UNITED STATES PATENT AND TRADEMARK OFFICE

APPLICATION NO.	FILING DATE	FIRST NAMED INVENTOR	ATTORNEY DOCKET NO.	CONFIRMATION NO.
10/631,928	07/31/2003	Clifford Teoh	01-170 (US02)	9672
41696 7590 02/25/2010 VISTA IP LAW GROUP LLP 12930 Saratoga Avenue Suite D-2 Saratoga, CA 95070				
EXAMINER				
NGUYEN, VI X				
ART UNIT		PAPER NUMBER		
3731				
MAIL DATE		DELIVERY MODE		
02/25/2010		PAPER

Office Action Summary

DETAILED ACTION

Sheet 7 of 7

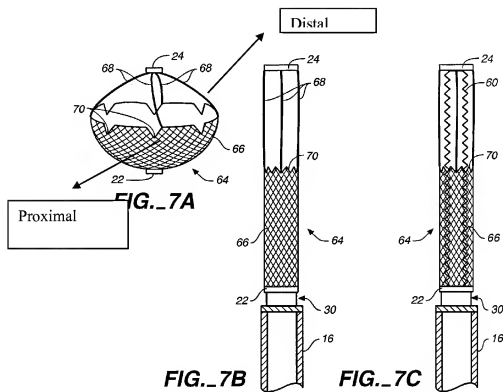
Claim 1: Wallace discloses a method of occluding an aneurysm (col. 2, lines 66-67, col. 3, lines 1-12), the aneurysm having a neck and a sac, the method comprising: delivering a liner 64 into the aneurysm, the liner having a proximal portion and a distal portion (**see annotated below, fig. 7a- on page 5 of this Office Action**), wherein the distal portion of the liner is more permeable than the proximal portion of the liner (it is noted that the distal portion has larger aperture which is inherently more permeable than the proximal portion which has smaller aperture), and wherein the liner 64 is delivered so that the proximal portion of the liner extends across the aneurysm neck (fig. 7d) and the distal portion of the liner is positioned within the aneurysm sac (col. 11, lines 65-67); and introducing embolics (col. 12, lines 3-7) through an opening in the proximal portion of the liner into an interior volume of the liner, wherein the

distal portion of the liner allows preferential permeation of the embolics from the liner interior volume into the sac of the aneurysm (col. 12, lines 3-7).

Claims 2 and 7: Wallace discloses the liner comprised a biodegradable and biocompatible material (col. 7, lines 3-17), and where the liner distal portion (fig. 7a) comprises a liner portion supported by struts 68.

Claims 5 and 6: Wallace discloses the liner proximal portion (fig. 7a) comprises a liner portion supported by expandable struts 68, and where the liner distal portion comprises the struts free of any covering (fig. 7a).

The applicant argues that the method of Wallace does not disclose the act of introducing embolics into an interior volume of the liner, wherein the distal portion of the liner allows preferential permeation of the embolics from the liner interior volume into the sac of the aneurysm. The examiner disagrees. It is noted that annotated below fig. 7a discloses such embolics introduced through an opening in the proximal portion of the liner into an interior volume of the liner (see col. 12, lines 3-4 and wherein the distal portion of the liner allows preferential permeation of the embolics from the liner interior volume into the sac of the aneurysm). Furthermore, the act of preferential permeation of the embolics from a liner interior volume into the aneurysm is possible in Wallace, since fig. 7a discloses aneurysm obstruction device 64 having parachute configuration which has an interior volume. Fig. 7d illustrates the deployment device 64 within an aneurysm 50 and wherein an embolic agent or other treatment agent can be delivered (see col. 12, lines 3-4) into the sac of aneurysm which does form an interior volume. Thus these arguments are not convincing and the rejection has been maintained.
